Subject: Mine Ventilation Plan, Section 75.370, 30 CFR 75, Upper  
Big Branch Mine-South, I.D. No. 46-08436, Performance  
Coal Company, Montcoal, Raleigh County, West Virginia

Denial

Re: Performance Coal Company  
Upper Big Branch Mine  
MSHA ID : 46-08436  
State ID: U-3042-92  
Ventilation Base Plan Revision

PERFORMANCE COAL COMPANY, INC. P.O. BOX 69, NAOMA, WV 25140		
	UPPER BIG BRANCH MINE		
	M.S.H.A. ID No. 46-08438	WV ID No. U-3042-92	
	Date: 11/30/09	SCALE: NA	DWG No. 1 of 1
	DRAWN BY: RL 3 Staff	CHECKED BY:	
	Face Ventilation Typical Gateroad Development		
VENTILATION PLAN

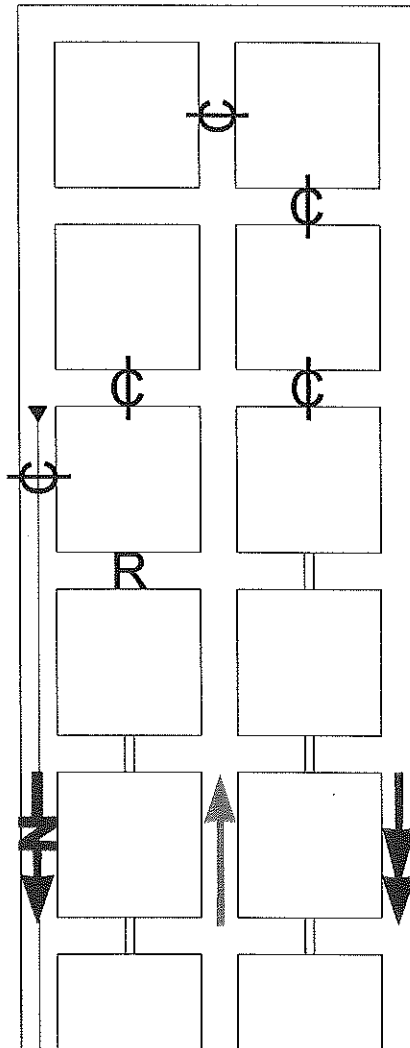
The revision cannot be approved as submitted. The submittal contains numerous errors and discrepancies which are detailed on the marked-up copy of the submitted map. The errors and discrepancies include: ventilation controls shown conflict with ventilation plan revisions which were approved on September 4, 2009, October 29, 2009, and November 13, 2009; roof falls which impede travel and which eliminate the potential for compliance with 30 CFR 75.384 for the 2<sup>nd</sup> longwall panel in the district are not shown nor addressed; water accumulations within the active areas and within adjacent areas are not shown; a means for compliance with 30 CFR 75.334(c) is not provided (additional information is requested due to the recent shut-down resulting from blocked air courses due to water); actual air readings are not provided despite production has been on-going since September, 2009; belt air from the development section is shown to be ventilating the longwall face; and belt air from the number 1 entry

of the Headgate 1 North does not meet the requirements of newly promulgated regulations (December 2008).

In addition, the submittal does not clarify how the return stopping line shown on the longwall face sketch is to be traveled or maintained, adequate details if the air courses are to become common or if the return stopping line is to be reconstructed. Measuring Points (MP) shown on the face sketch must also be checked for proper air direction. Furthermore, the gate road development face sketch (3-entry) contains a statement, "Number of entries may vary provided the ventilation scheme does not change." which is inappropriate for the projections and system shown on the attached maps.
